# PLAN COMMISSION

October 18, 2021

**BLOOMINGTON PLAN COMMISSION  
STAFF REPORT  
Location: 335 W. 8<sup>th</sup> Street**

**CASE #: SP-27-21  
DATE: October 18, 2021**

PROJECT NO. 03  
SHEET TITLE  
**SITE FEATURES PLAN**

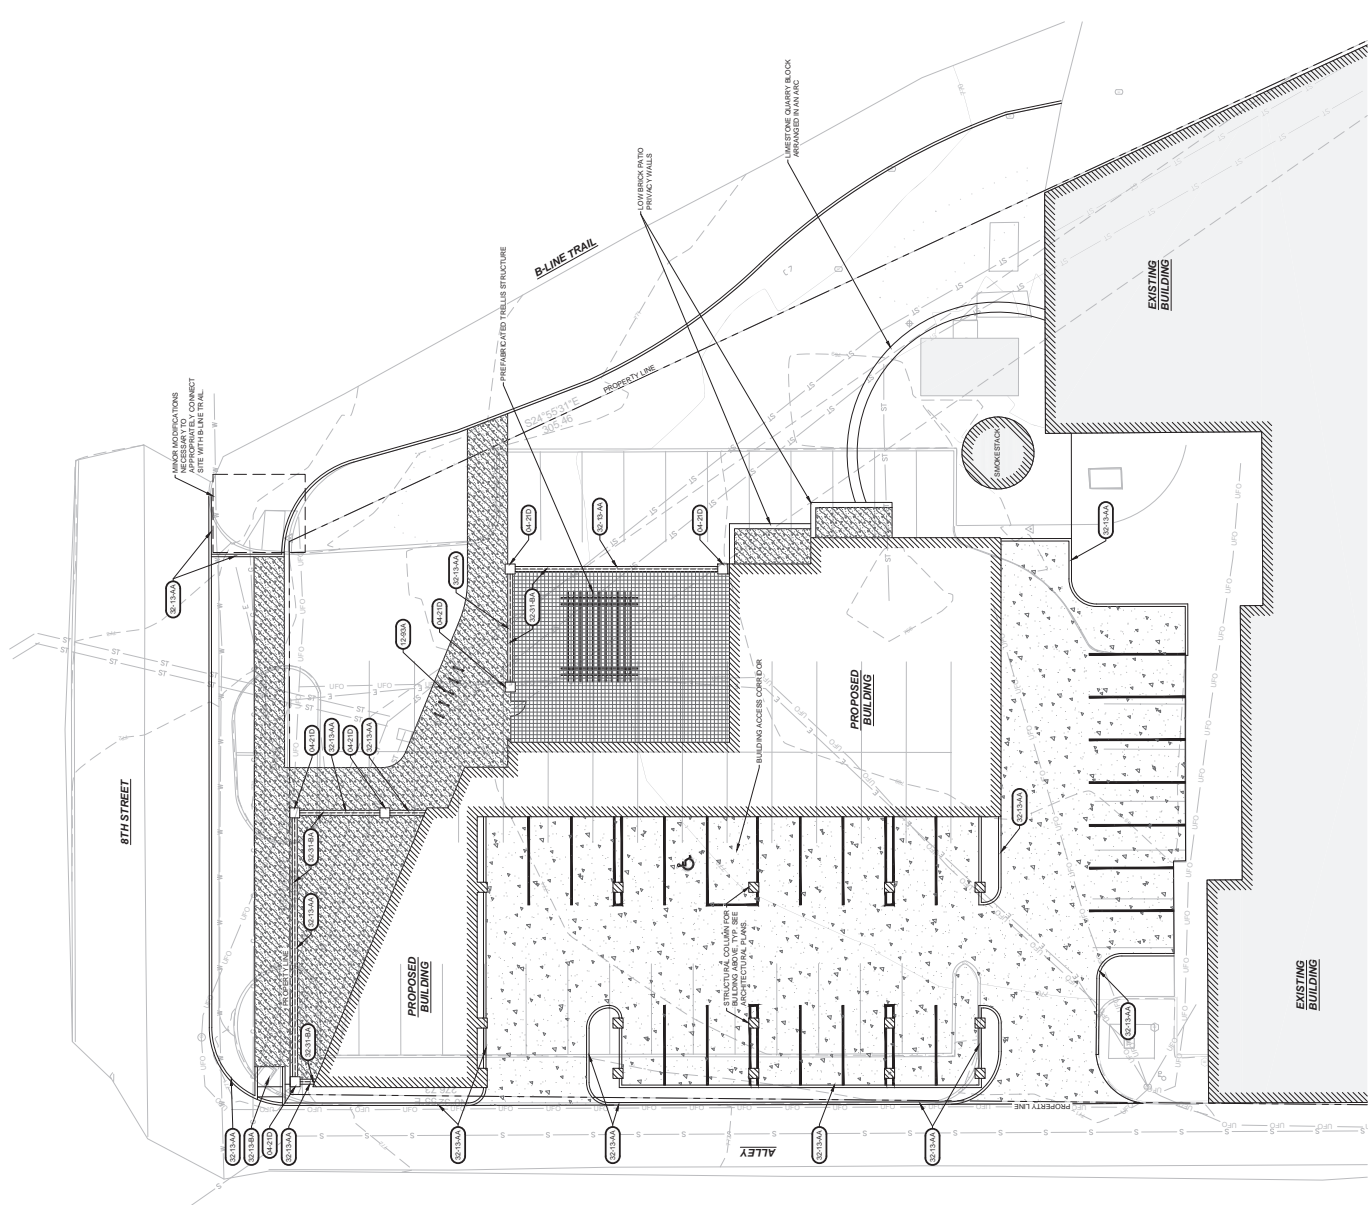
The Landscape Plan needs to be finalized with the grading permit. Some plant species will need to be changed (example is *Ulmus x 'Frontier'*), and the amount of pervious surface needs to be calculated to determine the quantity of interior plants.

1.) Revise the Landscape Plan prior to the Grading Permit issuance.
